**STATE OF RHODE ISLAND
COASTAL RESOURCES MANAGEMENT COUNCIL
ENFORCEMENT REPORT ADDENDUM
SEPTEMBER 16, 2025**

RE: CRMC Enforcement File 23-0185

LOCATION: Plat 167, Lot 2, 950 North Quidnessett Road, North Kingstown, RI

OWNER: Quidnessett Country Club, Inc.

COASTAL RESTORATION SITE DEVELOPMENT PLANS

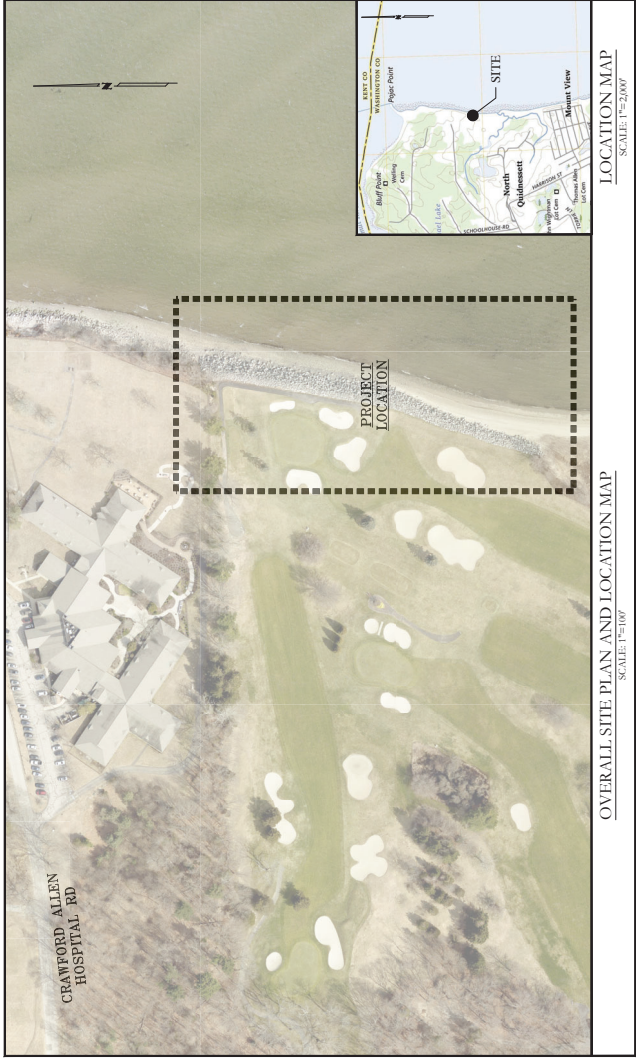
On August 5, 2025, you submitted a letter and a plan titled "Coastal Restoration Plan", dated August 4, 2025, by Cherenzia & Associates, LTD. This plan is unacceptable for the following reasons:

- The plan proposes a geotextile cellular barrier system (manufactured by Trapbag)". This system does not meet the definition of "nonstructural shoreline protection" (see 650-RICR-20-00-1.1.2(97)).
- New structural shoreline protection is prohibited on shorelines abutting Type 1 waters (see 650-RICR-20-00-1.3.1(G)(3)(a)).
- The "toe of berm" extends seaward of the blue line labeled, "approximate toe of coir envelope" as shown on the plan titled "Previous Approved Plan Overlay", dated revised February 3, 2025.

- The plan does not propose deep rooted native vegetation of appropriate size and density throughout all areas of previously vegetated natural buffer zone.

- Removal of all unauthorized riprap and fill.
- The "toe of berm" be no further seaward than the blue line labeled, "approximate toe of coir envelope" as shown on the plan titled "Previous Approved Plan Overlay", dated revised February 3, 2025.
- Deep rooted native vegetation of appropriate size and density throughout all areas of previously vegetated natural buffer zone.

COASTAL RESTORATION SITE DEVELOPMENT PLANS

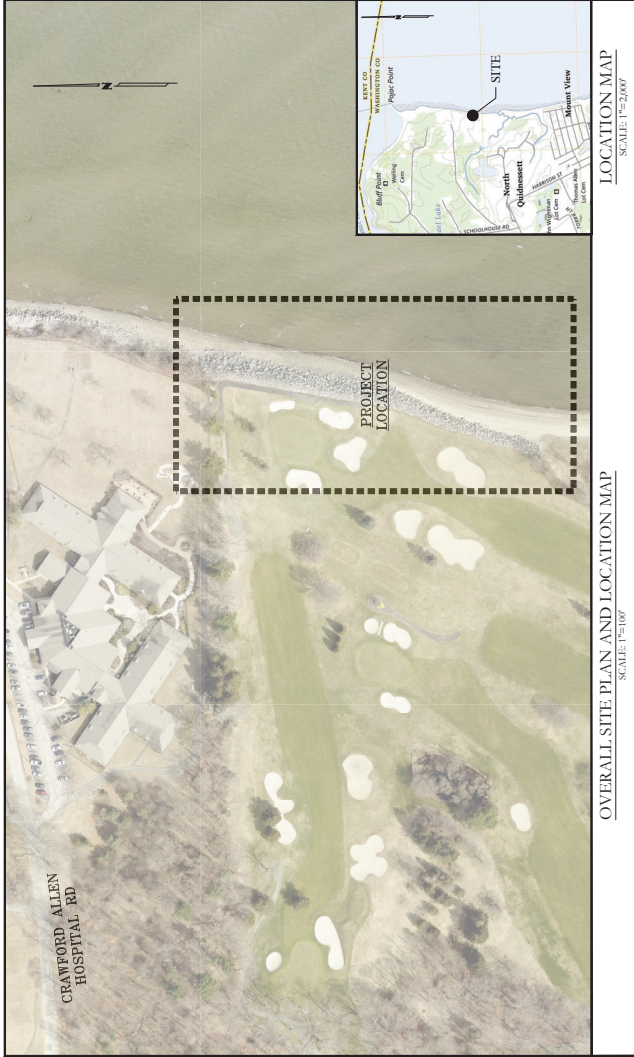
On September 5, 2025, you submitted a letter and a plan titled "Coastal Restoration Plan", revised September 5, 2025, by Cherenzia & Associates, LTD. This plan again fails to address any of the restoration criteria as previously listed and is again unacceptable for the same reasons as the August 4, 2025, plan:

- The plan proposes a geotextile cellular barrier system (manufactured by Trapbag)". This system does not meet the definition of "nonstructural shoreline protection" (see 650-RICR-20-00-1.1.2(97)).
- New structural shoreline protection is prohibited on shorelines abutting Type 1 waters (see 650-RICR-20-00-1.3.1(G)(3)(a)).
- The "toe of berm" extends seaward of the blue line labeled, "approximate toe of coir envelope" as shown on the plan titled "Previous Approved Plan Overlay", dated revised February 3, 2025.
- The plan does not propose deep rooted native vegetation of appropriate size and density throughout all areas of previously vegetated natural buffer zone.

- Removal of all unauthorized riprap and fill.
- The "toe of berm" be no further seaward than the blue line labeled, "approximate toe of coir envelope" as shown on the plan titled "Previous Approved Plan Overlay", dated revised February 3, 2025.
- Deep rooted native vegetation of appropriate size and density throughout all areas of previously vegetated natural buffer zone.
